Subject: Independent Expert Advisory Panel for Mining MOD6 Recommendations

I refer to the request for information (RFI-77450713) from the Department of Planning, Housing and Infrastructure (DPHI) requesting that Ulan Coal Mines Pty Limited (UCMPL) review and respond to the recommendations provided in the Independent Expert Advisory Panel for Mining (IEAPM) report for MOD6 received 31 October 2024.

Re: Ulan Coal Mine Complex MOD6 groundwater modelling and assessment independent review

Figure 1: Proposed Bore Location

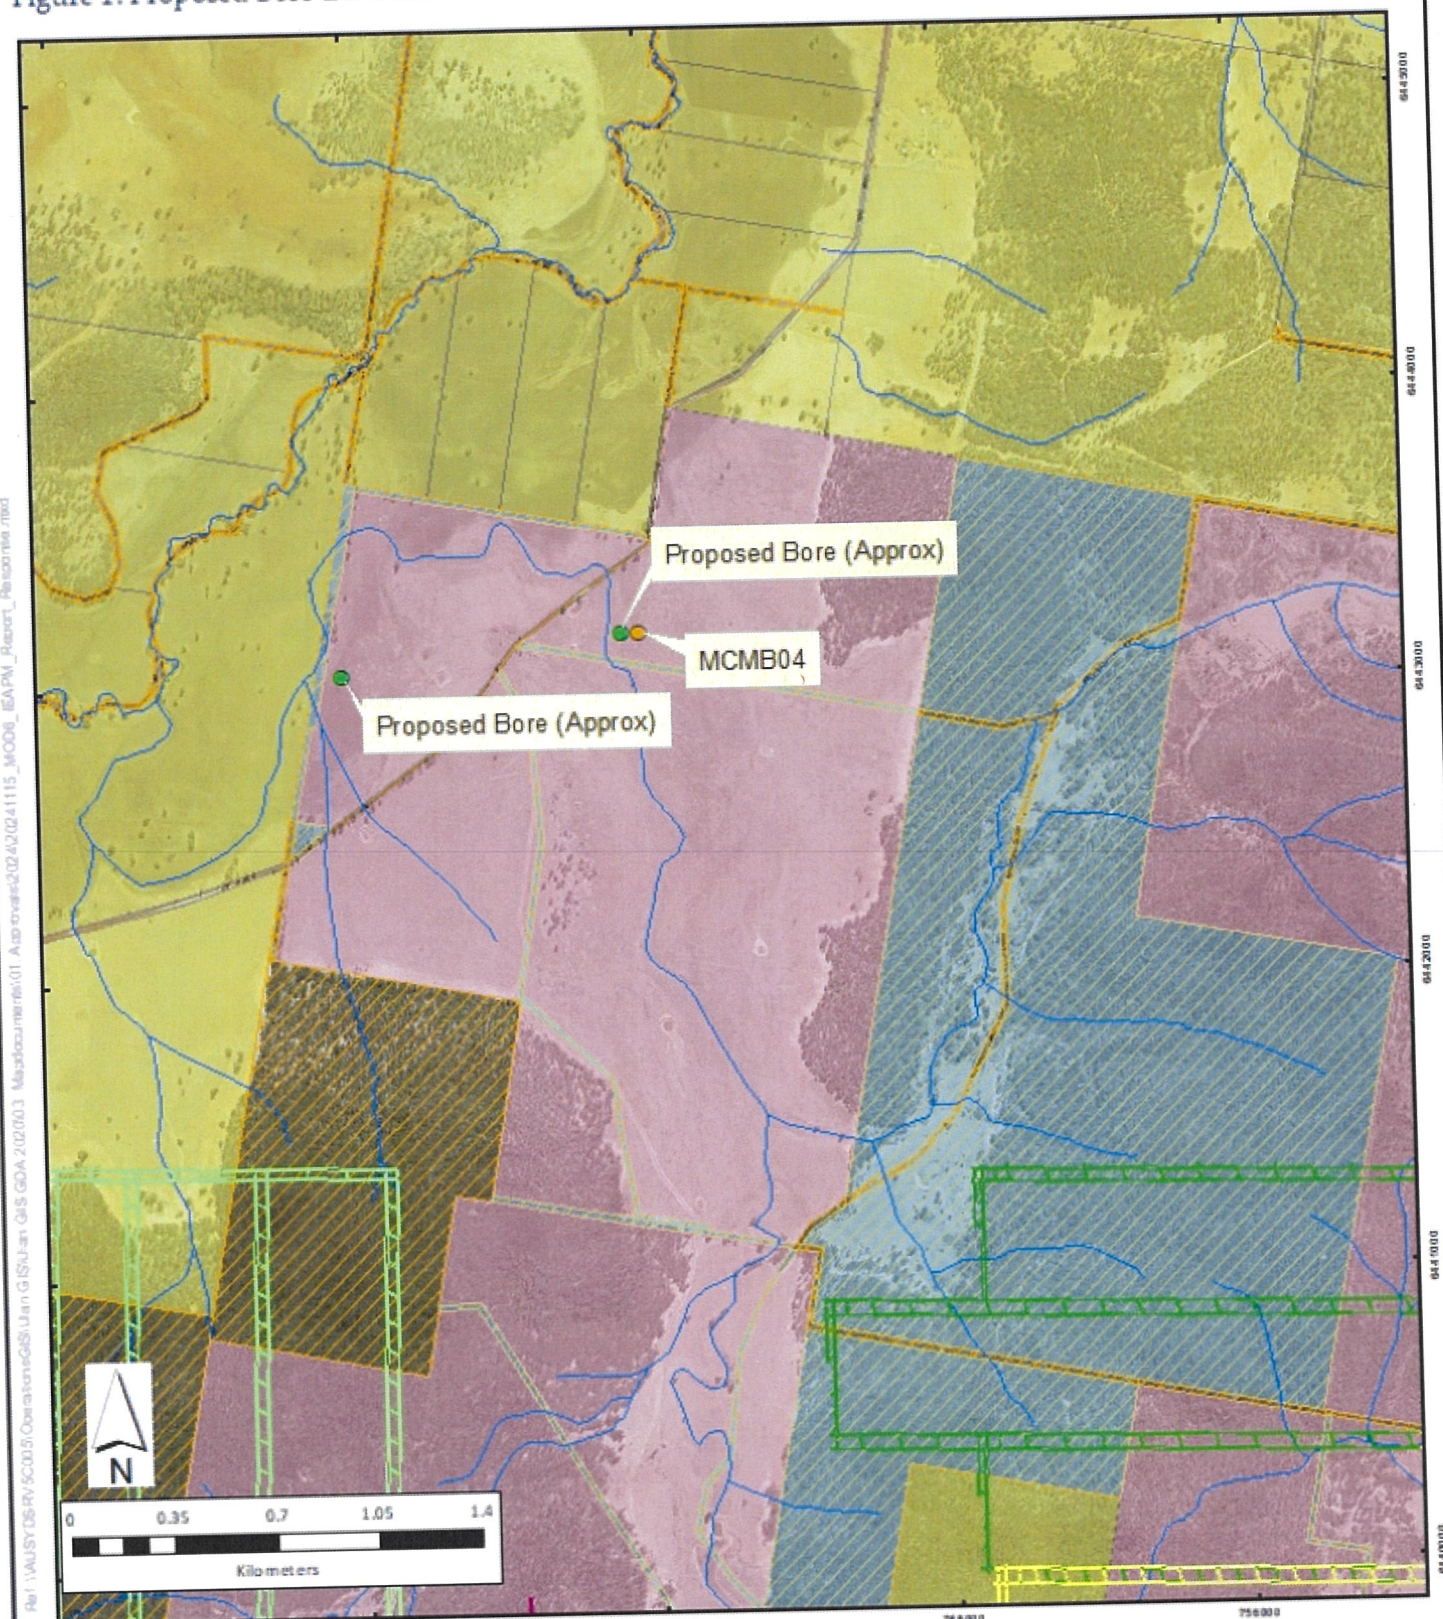
4. UCMPL will install deeper, nested piezometers next to MCMB04 and new nested piezometers or a VWP monitoring bore, close to the confluence of Mona Creek and the Talbragar River. The proposed bores will be located on UCMPL owned land, within the approximate location shown on Figure 1, in Attachment 1.
